**Department of Energy**

February 24, 1998

**DOE's Response to Comments  
Made by EEG to Docket A-93-02, dated 12/31/97**

## EEG Comment #1: Solubility - FMT Model and the database

Figure 10: Replicate 3- 2D/3D Comparison of Repository Saturation

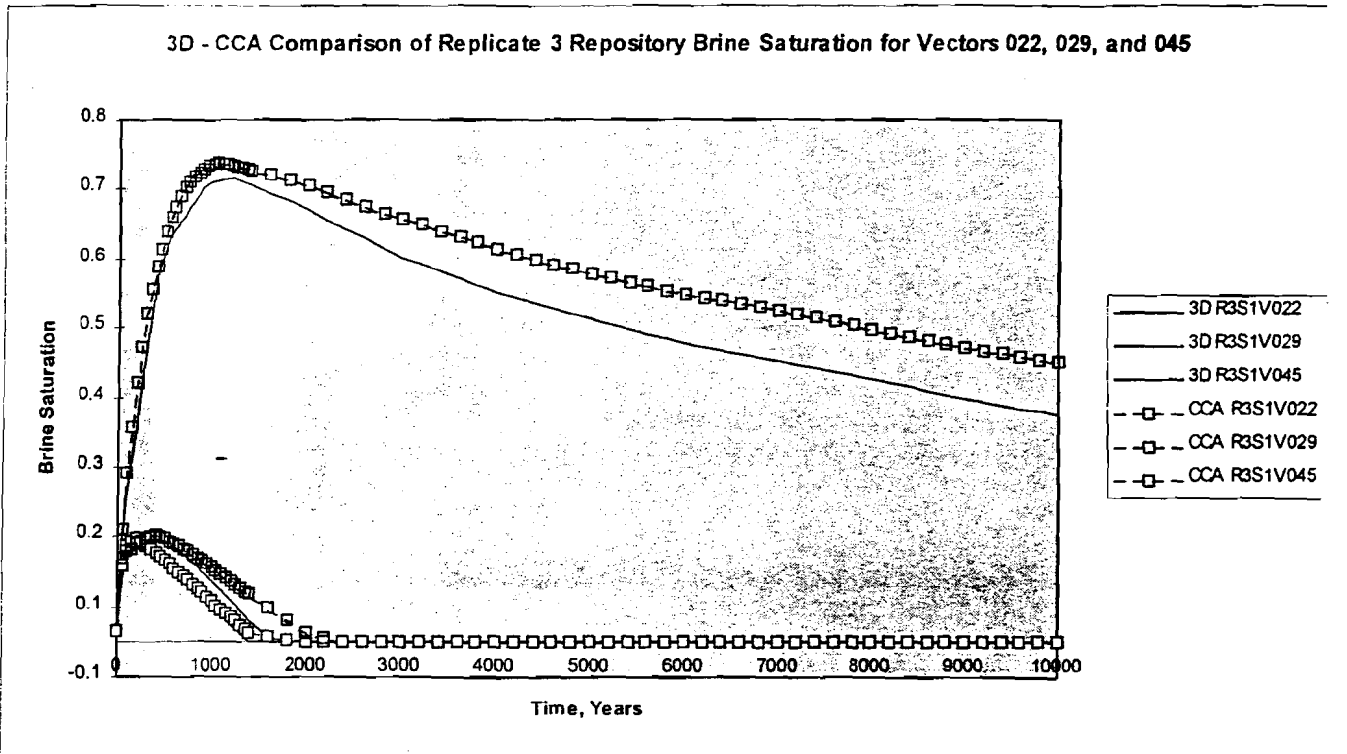
To resolve this issue, the EEG recommends that several 3D BRAGFLO simulations of the repository should be performed using the parameter values of vectors used in the CCA performance assessment. The 3D BRAGFLO simulations should be used to provide repository conditions for the normal suite of direct brine release calculations. The calculations should also be assessed in terms of impact on spillings calculations. Spallings simulations are probably not required to assess the impact. The following criteria may be used to select the CCA vectors for running the 3D simulations to bound the magnitude of the problem:

- Direct brine release calculations should be sensitive to increased brine saturations above the waste residual brine saturation. Vectors that had either large brine saturations or a mobile brine component (saturations above the residual saturation) are more likely to be sensitive to increased brine inflow. Figure 5.1.5 of the preliminary sensitivity analysis report (Helton, 1996) indicates one vector with a 10,000 year pressure above 14 MPa and a brine saturation above 0.4. This is a likely candidate.

- If the first simulations indicate a large change in saturation, then assess whether the 3D BRAGFLO simulations indicate a much larger number of significant direct brine releases than those calculated in the CCA. Simulations using brine saturations on the order of 0.1 and 0.3 should be performed.

Additionally, more complex supplementary 3D calculations were performed in concert with EEG's recommendations made during discussions with EEG at a January 17, 1998 meeting (Vaughn, Bean, Schreiber and Dotson, 1998). These results collectively show that the 2D geometry used by BRAGFLO in the 1996 CCA performance assessment calculations is appropriate and does not result in an underestimate of direct release during human intrusion. In all cases investigated (10 simulations using 9 CCA realizations) the 2D simulations consistently predict either the same or larger repository pressure and brine saturation than their 3D counterparts. Both larger pressure and brine saturation in the repository at the time of intrusion would lead to larger releases. Thus, the 2D geometry results in a conservative estimate of the releases when compared to results from a 3D representation. These calculations are also reproduced in Attachment 1.

In figures 5 through 10 the repository pressure and the brine saturation resulting from an additional 8 simulations are compared between the 2-D CCA simulation and their 3-D counterparts. The characteristics leading to the selection of these additional realizations are outlined in an earlier section. Vertical fracturing is disabled in the 3-D simulations as justified in Attachment 1. Both the pressure and brine saturation in the 2-D version are either nearly the same or slightly larger than their 3-D counterparts. Since larger pressure and higher brine saturation result in larger releases during drilling, everything else being equal, the 2-D geometry used by BRAGFLO for the CCA calculations leads to a conservative (larger) estimate of release than the 3-D representation.
